Development Services Staff Report

File Number	PL2024-319
File Name	PRELIMINARY DEVELOPMENT PLAN – 150 & Ward Apartments
Applicant	Milhaus
Property Address	3620 SW Ward Rd.
Planning Commission Date	April 24, 2025
Heard by	Planning Commission and City Council
Analyst	Adair Bright, AICP, Senior Planner

Figure 7 – Typical “Building A” (side elevation)

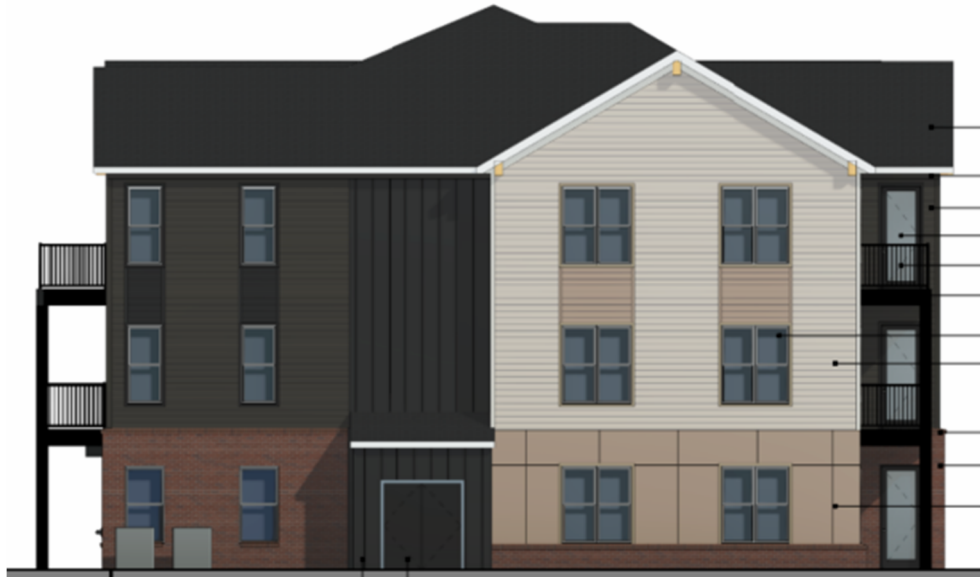
4. The applicant has requested a modification to UDO Sec. 5.510.B.4.c(6) pertaining to building design as required by the M-150 CDO. Staff has reviewed the request and supports the modification for the reasons identified below.

- **Requirement** – At least 20 percent of all walls facing a public street shall contain windows or doorways.
 - **Proposed** – Due to the orientation of the buildings and the site having a street on three out of the four sides, the side elevations of building types A, B, and C will face the street and have less than 20% windows or doorways.

- **Staff Recommendation** – Staff is supportive of the proposed modification since the intent is to ensure street-facing facades include a mix of materials and variation. The street facing facades use five different materials including the windows and doorways. On average, the street-facing facades of buildings A, B, and C will have 11%-17% containing windows or doorways.

4. A modification shall be granted to UDO Sec. 5.510.B.4.c(6) to reduce the required percent of windows or doorways on walls facing a public street from 20% to 11% for Building Type C and 17% for Building Types A and B.

Figure 8 – Site Plan showing property lines and existing right-of-way (property line shown in thick dashed line)

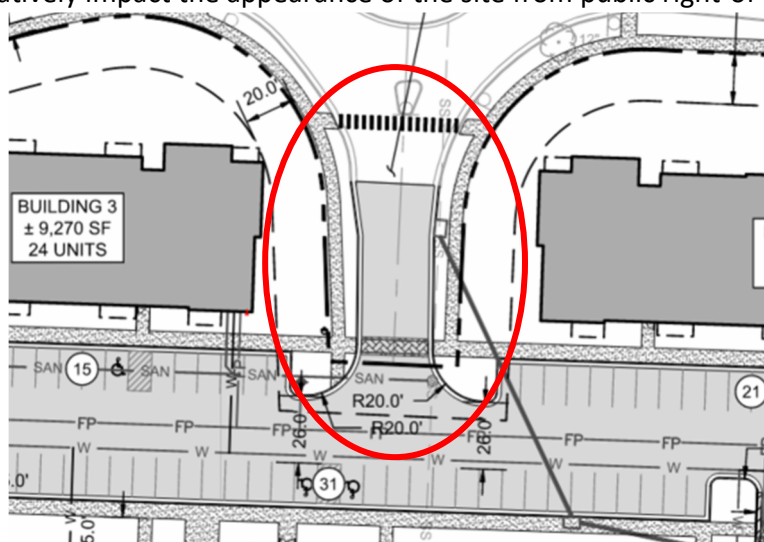
5. The applicant has requested a modification to UDO Sec. 8.620.B.1 pertaining parking lot setbacks. Staff has reviewed the request and supports the modification for the reasons identified below.
 - **Requirement** – All parking lots shall be set back a minimum of 20 feet from any public right-of-way or private street edge of pavement.
 - **Proposed** – The applicant is proposing to reduce the parking lot setback adjacent to the right-of-way for the SW Arborwalk Boulevard roundabout from the required 20-ft. to 0-ft.
 - **Staff Recommendation** – Staff is supportive of the proposed modification due to how far the right-of-way cuts into the proposed site. The right-of-way extends 60-ft. south into the site from the edge of pavement of the roundabout. Approval of the modification is not anticipated to negatively impact the appearance of the site from public right-of-way.

5. A modification shall be granted to UDO Sec. 8.620.B.1 to reduce the required parking lot setback adjacent to the right-of-way for the SW Arborwalk Boulevard roundabout from 20-ft. to 0-ft.
